Greensmaster® 3100

Subject: Controlling Static Discharge at Hydraulic Reservoir

PART NO. 98–1464 | INSTALLATION INSTRUCTIONS

ANTI–STATIC SHIELD KIT
GREENSMASTER 3100

Figure 1

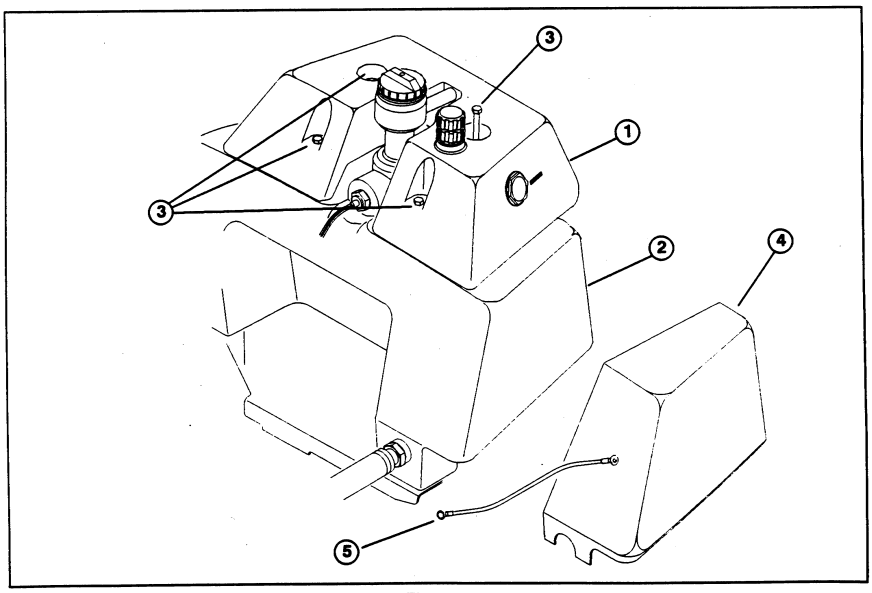
The products listed above may buildup static electricity on the external surface of the hydraulic reservoir and discharge this buildup to the engine air filter cover. Static discharge may be more predominant in some regions due to atmospheric conditions and humidity levels. Although this situation results in no known hazards, an operator may complain about the condition.

To relieve this condition, Anti Static Shield Kit (98-1464), is available from your Toro Distributor at no charge. This kit fits over the left side of the hydraulic tank and discharges static buildup through a connection to the frame. Installation instructions are included with the kit.

1. Loosen (4) capscrews securing auxiliary hydraulic tank to main tank.
2. Gently lift up on left end of auxiliary tank.
3. Slide anti–static cover over main tank while positioning cover slot over hydraulic fitting on front of tank.
4. Lower end of tank and tighten capscrews.
5. Connect shield ground wire to negative terminal on battery.
